<b>Product/Process Change Notice (PCN)</b>							
<input type="checkbox"/> Major Change <input checked="" type="checkbox"/> Minor Change							
<b>PCN Number:</b> PCN_FrqXTAL_20250212  <b>Affected Series:</b> WE-XTAL  <b>Affected Part Number:</b> 830108254201, 830108131401, 83010813160, 830108049101  <b>PCN Date:</b> 2024-11-12 (YYYY-MM-DD) <b>Effective Date:</b> 2025-02-12 (YYYY-MM-DD)	<b>Change Category:</b> <input type="checkbox"/> Equipment/Location <input checked="" type="checkbox"/> General Data <input type="checkbox"/> Material <input type="checkbox"/> Process <input type="checkbox"/> Product Design <input type="checkbox"/> Shipping/Packaging <input type="checkbox"/> Supplier <input type="checkbox"/> Software						
<b>Contact:</b> Product Management  <b>Phone:</b> +49 (0) 7942 - 945 5001  <b>Fax:</b> +49 (0) 7942 - 945 5179  <b>E-Mail:</b> pcn.eisos@we-online.com	<b>Datasheet Change:</b> <input checked="" type="checkbox"/> Yes <input type="checkbox"/> No  <b>Attachment:</b> <input type="checkbox"/> Yes <input checked="" type="checkbox"/> No						
<b>DESCRIPTION OF CHANGE:</b> Because of a database mismatch, Würth Elektronik eiSos will correct the packaging details (1), produ

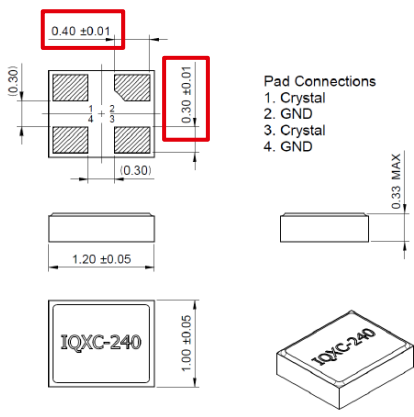
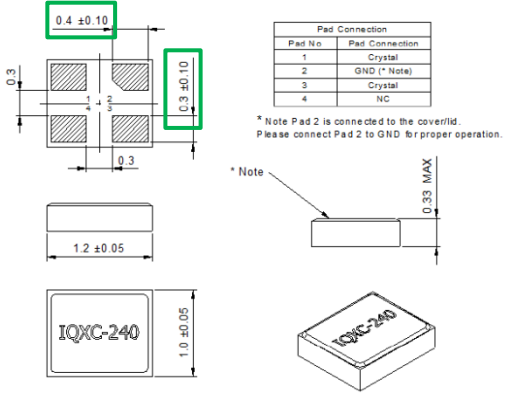
Before	After												
Product Dimensions	 <p>Pad Connections                      1. Crystal                      2. GND                      3. Crystal                      4. GND</p>

<p>* Note Pad 2 is connected to the coverlid.                      Please connect Pad 2 to GND for proper operation.</p>	Pad Connection		Pad No.	Pad Connection	1	Crystal	2	GND (* Note)	3	Crystal	4	NC
Pad Connection														
Pad No.	Pad Connection													
1	Crystal													
2	GND (* Note)													
3	Crystal													
4	NC
